## 2024.03.20 TSW200 DIN Rail bracket change

PCN Number: PCN\_TSW200\_2023.03.20

Detailed description

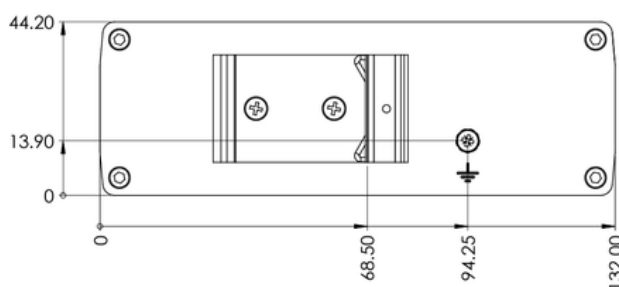
Beginning in Q2 of 2024, the current screw-on DIN Rail bracket in the TSW200 switch will be replaced with an integrated one. The new DIN Rail bracket will be shifted to the left by 0.96 mm.

Old DIN Rail bracket:

New DIN Rail bracket:

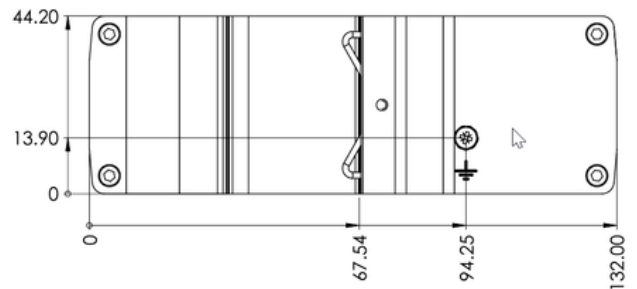
Dimensions of old DIN Rail bracket:

Dimensions of new DIN Rail bracket:
